In Regards to Package Representation Comment Resolution

Liav Ben-Artzi - Marvell Technology Group

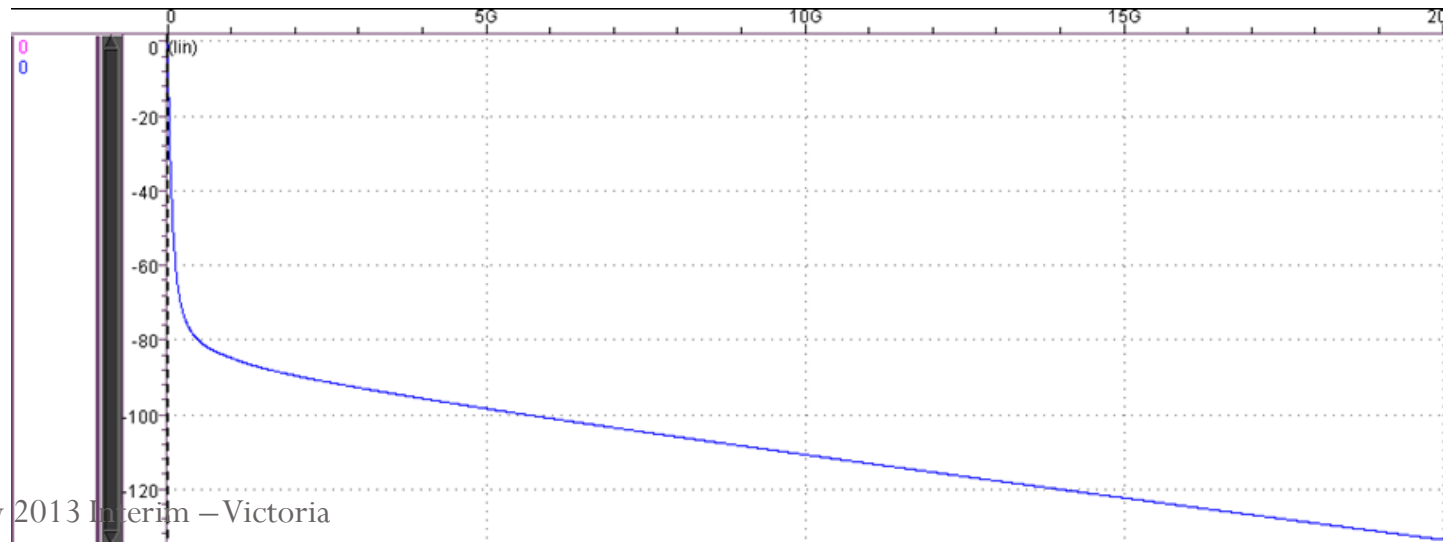
- Rho0 and Gamma0, each has an imaginary part which is not physical. The imaginary part was a result of the approximation process.
- Simply removing the imaginary part of the DC coefficient can work only in the case of a very small imaginary part (that can be neglected).

Having 7 Coefficients... What happens by zeroing $\rho_0(\text{Imag})$

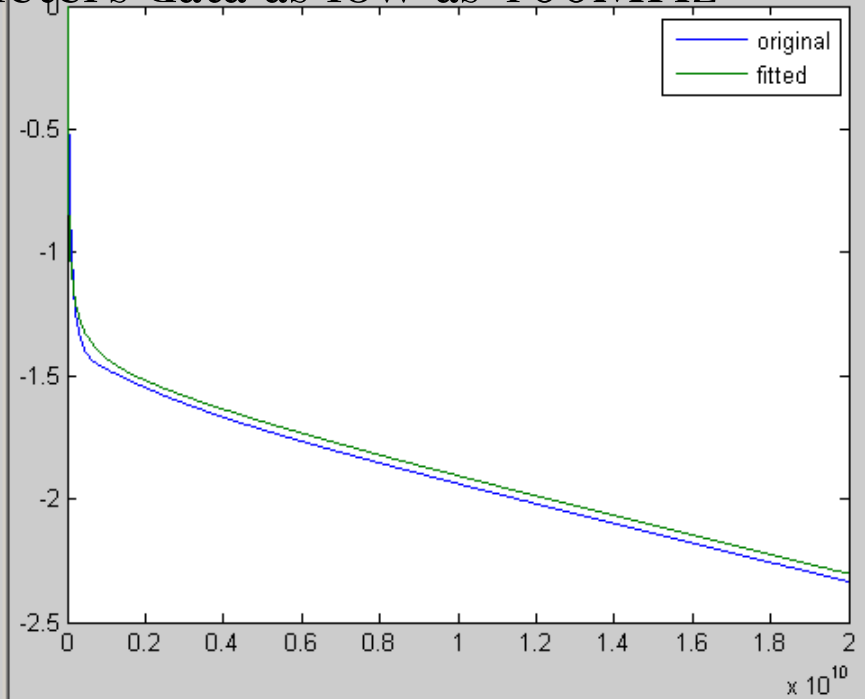
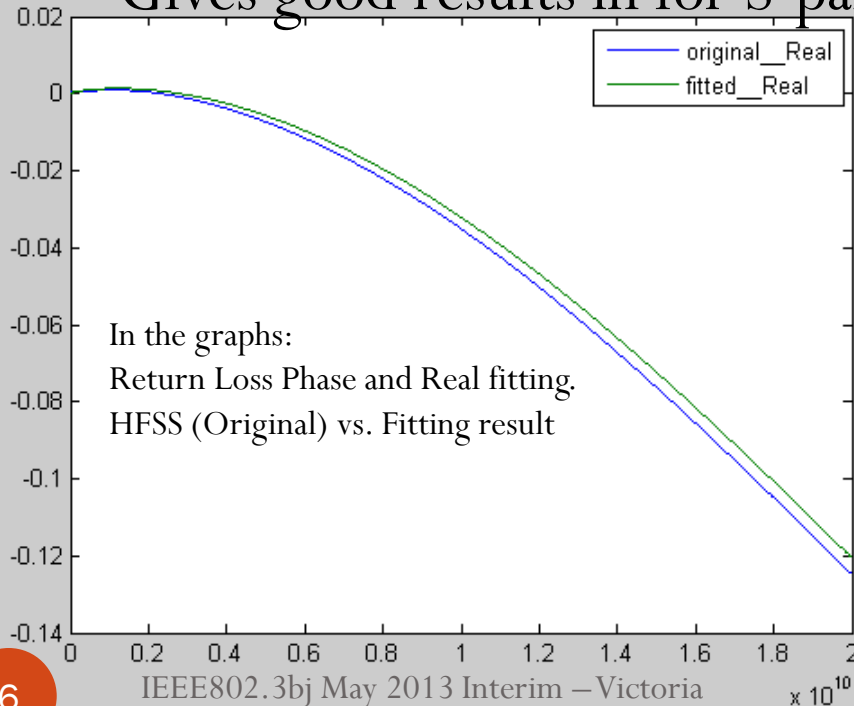
- Real and phase “almost” match the HFSS model , but not quite enough if we want to include very low frequency details...
- $S_{22} = S_{11} = \exp(\rho_0 + \rho_1 * \sqrt[16]{f} + \rho_2 * \sqrt[8]{f} + \rho_3 * \sqrt[4]{f} + \rho_4 * \sqrt{f} + \rho_5 * f + \rho_6 * f^2)$

- Gives good results in for S-parameters data as low as 100MHz

Having 8 Coefficients

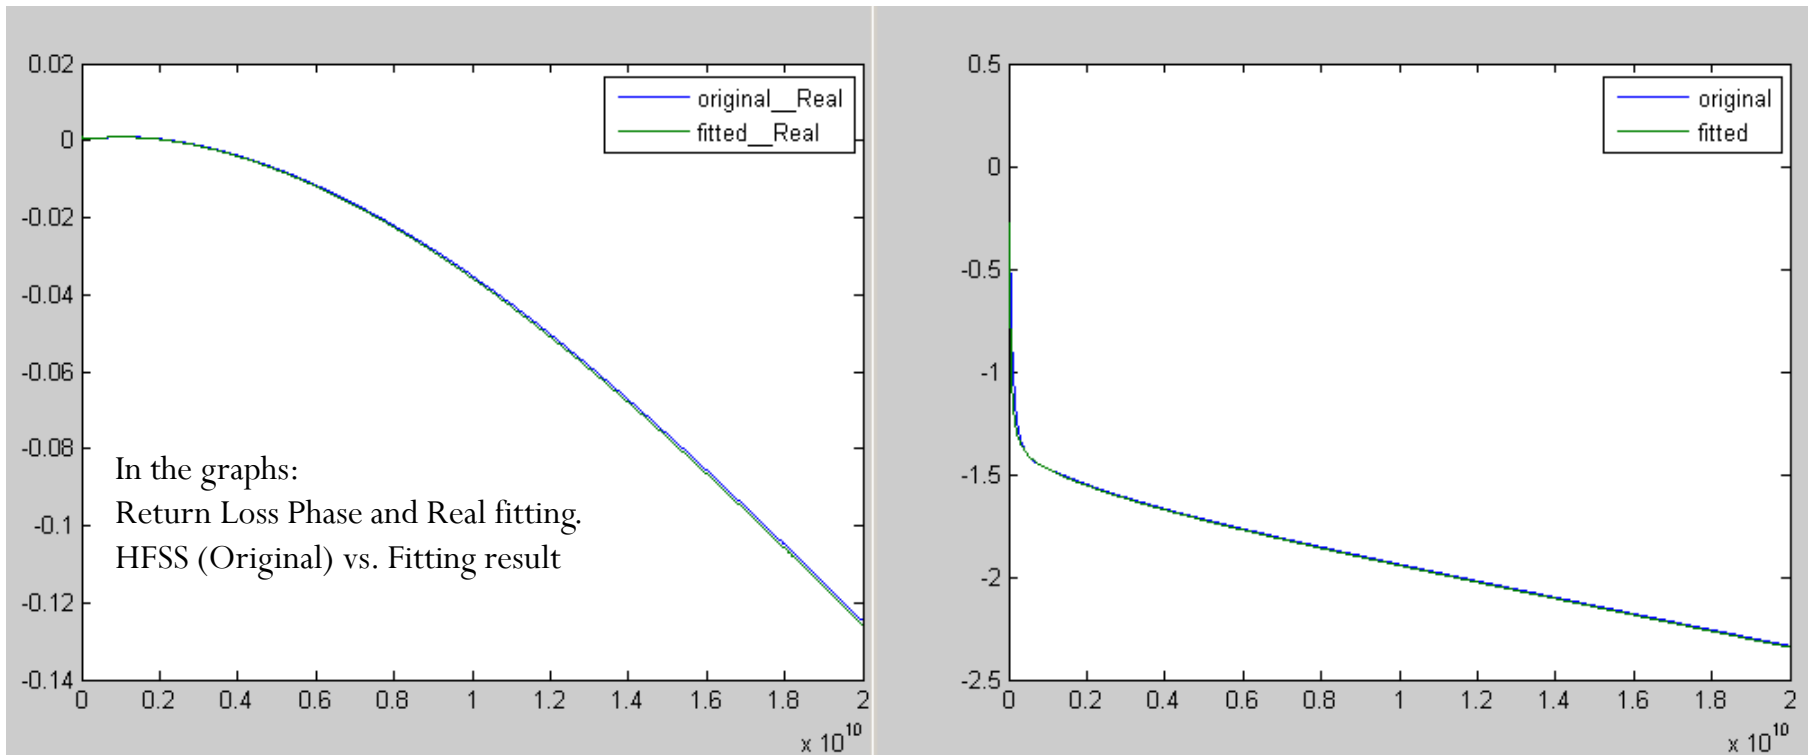
- A very good correlation down to very close to DC or real and phase... but requires 8 coefficients... Let's try a different approach...

In the graphs:
Return Loss Imag and Real fitting.
HFSS (Original) vs. Fitting result

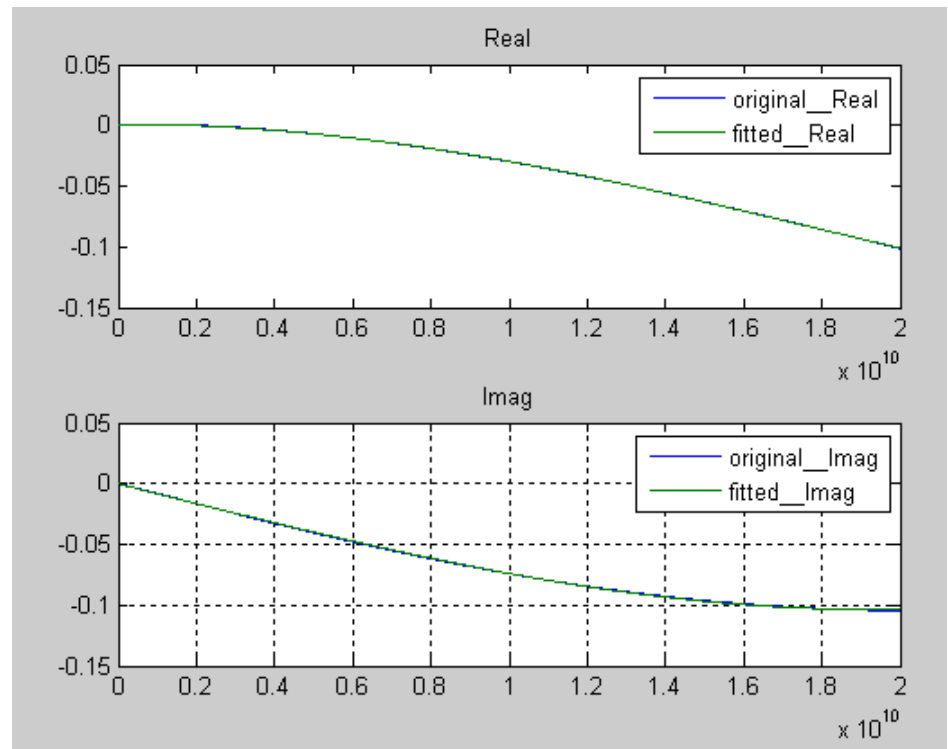
- The above fit provides adequate accuracy to both imaginary and real parts of the return loss while maintaining low coefficient amount:

$$S_{11} = S_{22} = \rho_0 + \rho_1 * f + \rho_2 * f^2 + \rho_3 * f^3 + \rho_4 * f^4$$

Suggested Remedy - Results

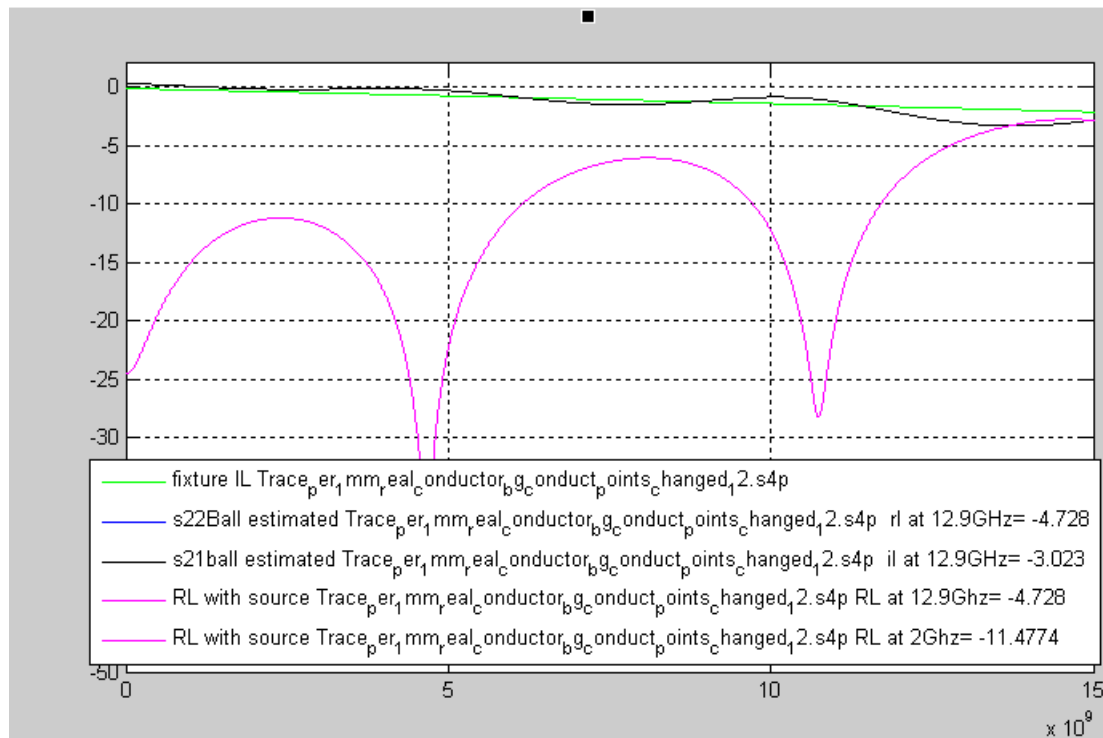
- The suggested coefficients follow the package return loss requirements as were agreed by the package return loss ad-hoc and presented in Benartsi_3bj_01_0113

- This requires updating equation (93A–9) to EQ1
- Correct table 93A–2 - Transmission line model parameters values and add required coefficients according to the Table1 on slide 11

The Resulting Return Loss

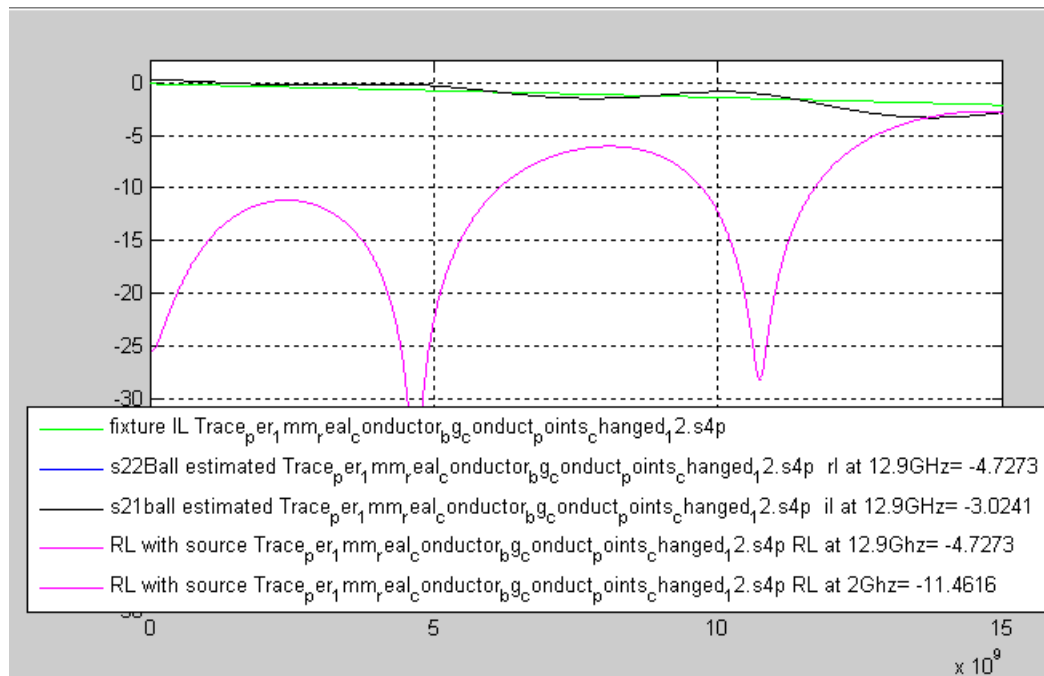
- The suggested coefficients follow the package return loss requirements as were agreed by the package return loss ad-hoc and presented in Benartsi_3bj_01_0113

- Change equation (93A–9) to:

$$S_{11} = S_{22} = \exp(\rho_0 + \rho_1 * \sqrt[32]{f} + \rho_2 * \sqrt[16]{f} + \rho_3 * \sqrt[8]{f} + \rho_4 * \sqrt[4]{f} + \rho_5 * \sqrt{f} + \rho_6 * f + \rho_7 * f^2)$$

- Correct table 93A–2 - Transmission line model parameters values and add required coefficients according to the Table2 on slide 9
